AQUATIC RESOURCES DELINEATION TECHNICAL MEMORANDUM ADDENDUM Version2

Date: May 14, 2025

Re: **Enduring's NE Lybrook WSW 2306-06P Oil and Gas Project, Rio Arriba County, New Mexico, Aquatic Resources Delineation Technical Memorandum Addendum Version2/ SWCA Project No. 75253-082**

Figure 7. GoogleEarth Imagery Date 5/21/2024 – P03 - evidence of manmade pond; note the dike on the eastern side.

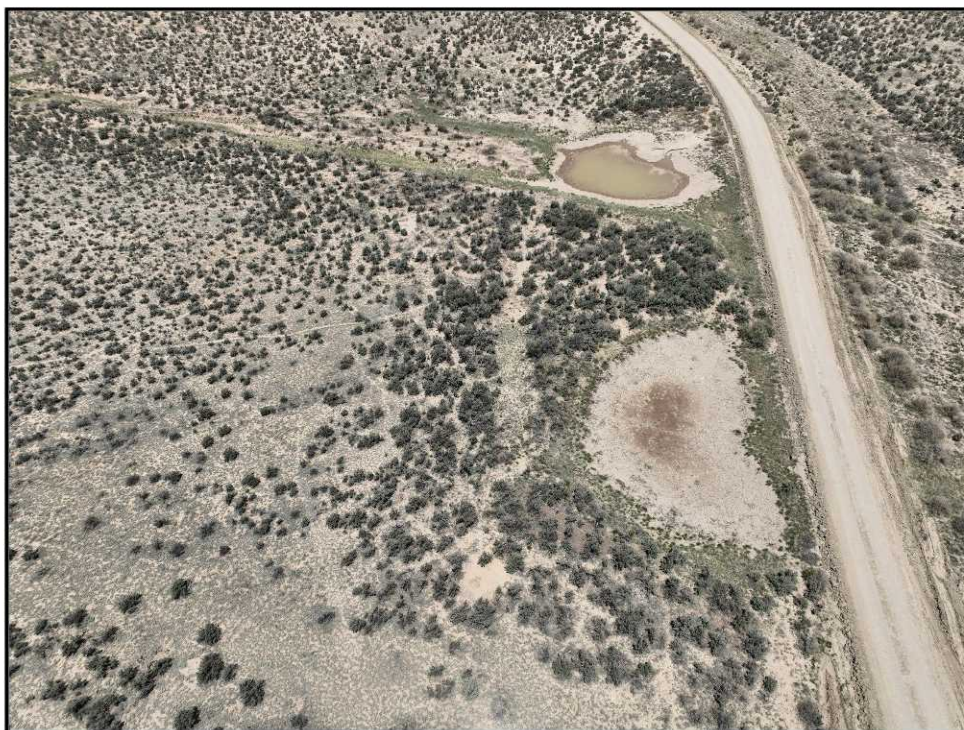
Additionally, on May 9, 2025, Enduring notified SWCA that ponds observed within the survey area and described in the Technical Memorandum also required clarification per a request from the EMNRD-OCD. The EMNRD-OCD requested the manmade or natural depression status of the ponds be clarified.

SWCA further investigated historical imagery available from Google Earth Pro. Imagery from 2014 shows what appears to be heavy equipment tracks from grading or cleaning of the ponds P01 and P02 (Figure 5) (Google Earth Pro 2025). Imagery from 2017 of ponds P01 and P02 show the ponds with contained water held by constructed dikes on the western and southern sides of the ponds (Figure 6) (Google Earth Pro 2025). Imagery from 2024 of P03 shows what appears to be a constructed dike to the eastern side of the pond (Figure 7) (Google Earth Pro 2025).

The three ponds observed in the survey area were identified as artificial or manmade ponds, created by excavating or diking dry land, and used exclusively for such purposes as stock watering or settling basins. These types of ponds are typically excluded from waters of the U.S. jurisdiction (40 Code of Federal Regulations 120.2(b)(5)). Although hydrology indicators were present at the ponds, including water, saturation, and mud cracks, hydrophytic vegetation was not. Due to soil disturbances from grading and excavating, and the relative newness of the ponds having been constructed in what was likely upland, hydric soils were not expected to be present. The ponds did not meet the criteria necessary for three-parameter wetlands due to the lack of required indicators. These features are unlikely to be considered jurisdictional.
